Access Compliance Report Public Rights-of-Way (Curb Ramps)

Main Street: PURDY_ST Cross Street: BOLSA_AVE_FRONTAGE_ROAD Location: NE

ADA ID: RPRK220203144841 Ramp Type: Type 4 - Parallel Initial Pass/Fail: Fail Overall Compliance: No Severity Score: 15

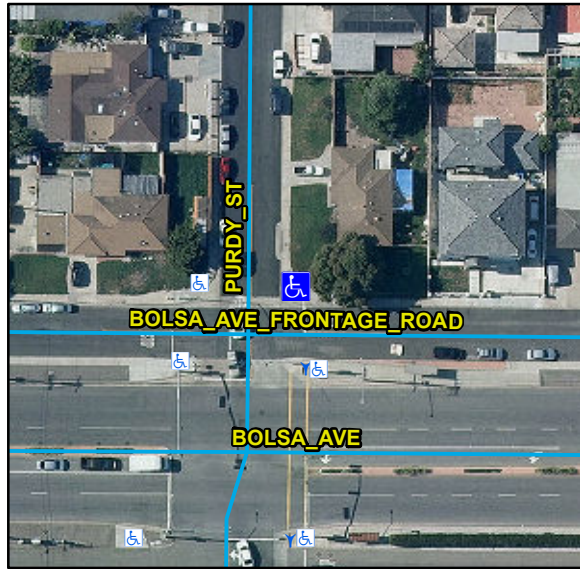
Compliance	Description	Data	Compliance	Description	Data
N/A	Ramp Length LT (in)	101	N/A	Ramp Length RT (in)	117
Yes	Ramp Width LT (in)	59	Yes	Ramp Width RT (in)	62
Yes	Ramp Run Slope LT (%)	5.8	No	Ramp Run Slope RT (%)	8.6
Yes	Ramp Cross Slope LT (%)	0.3	Yes	Ramp Cross Slope RT (%)	0.6
N/A	Landing Present	N/A	N/A	DWS Provided	N/A
N/A	Landing Length (in)	N/A	N/A	DWS Contrast	N/A
N/A	Landing Width (in)	N/A	N/A	DWS Length (in)	N/A
N/A	Landing Run Slope (%)	N/A	N/A	DWS Full Width	N/A
N/A	Landing Cross Slope (%)	N/A		DWS Offset Type	N/A
N/A	Landing Movement Obstructed?	N/A	N/A	DWS Offset Left (in)	N/A
	Landing Movement Type	N/A	N/A	DWS Offset Right (in)	N/A
N/A	Landing Shared	N/A			
N/A	Clear Space	Yes			
N/A	Clear Space To Crosswalk (in)	N/A			
N/A	Marked Crosswalk 1	No	N/A	Marked Crosswalk 2	No
	Crossing 1 Direction	W		Crossing 2 Direction	S
	Marked Crosswalk 1 Width (in)	N/A		Marked Crosswalk 2 Width (in)	N/A

Remove & Replace Curb Ramp With Two New Directional Ramps or Equivalent.

R304.3.2, STD 1115
